September 11, 2017

SUBJECT: Submitting Revised Lead-Pot Label for TheraSphere Distributed Under
NRC License No. 54-28275-02MD 03030793

A copy of the revised Lead-Pot label is appended to this letter.

Proof # 2
 Client: Nordion (Canada) Inc
 Item #: 10094908
 M.S.F.#: 347347
 Date: July 7, 2017
 Proof not for colour accuracy.

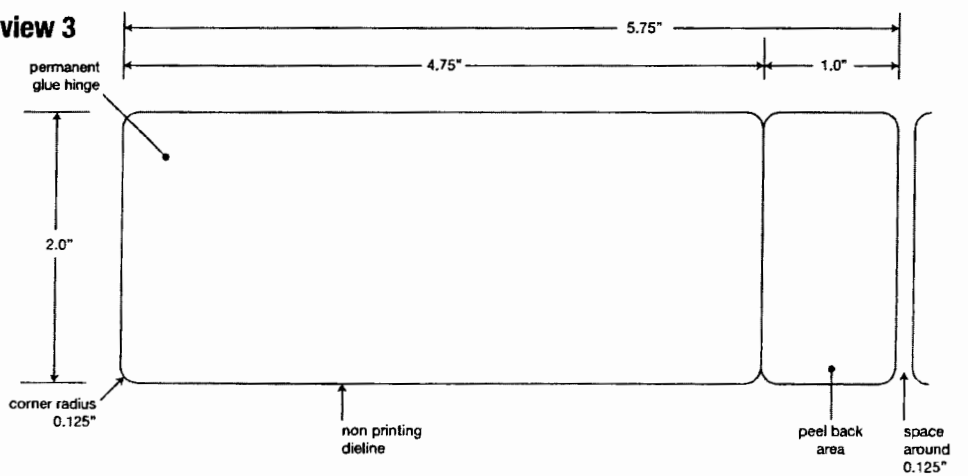
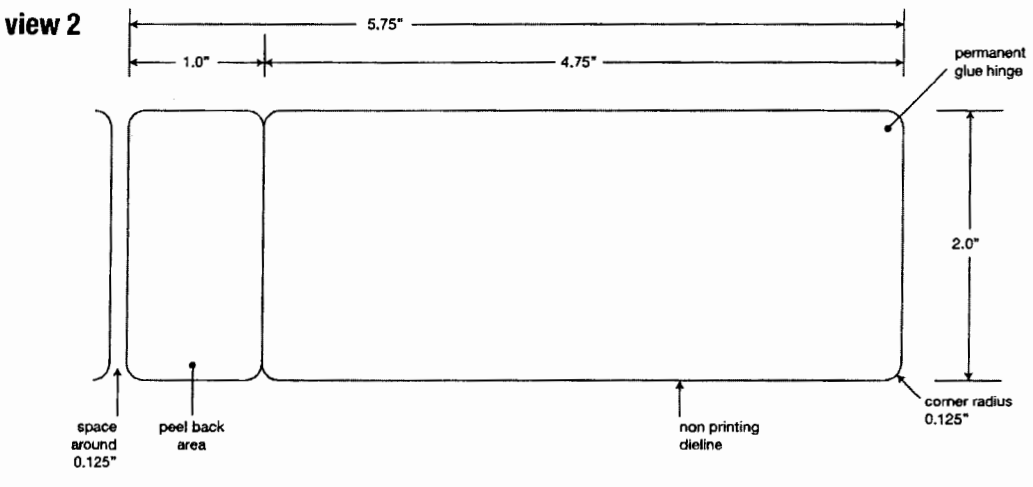
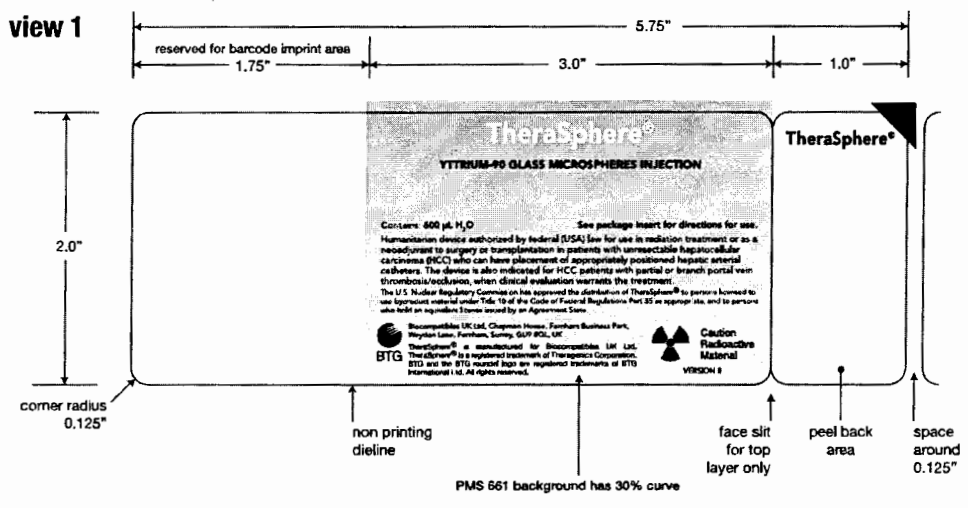
The current TheraSphere Lead-Pot label references compliance with various sections of 10 CFR Part 35, namely 35.57, 35.400 and 35.500. The references are historical and are not necessarily indicative of the full or current compliance requirements. Nordion wishes to revise the reference on the Lead-Pot label. The current and revised wordings are provided below.

Current Wording

The U.S. Nuclear Regulatory Commission has approved distribution of TheraSphere to persons licensed to use byproduct material identified in 35.57, 35.400 and 35.500, as appropriate and to persons who hold an equivalent license issued by an Agreement State.

Revised Wording

The U.S. Nuclear Regulatory Commission has approved distribution of TheraSphere to persons licensed to use byproduct material under Title 10 of the Code of Federal regulations Part 35 as appropriate and to persons who hold an equivalent license issued by an Agreement State.
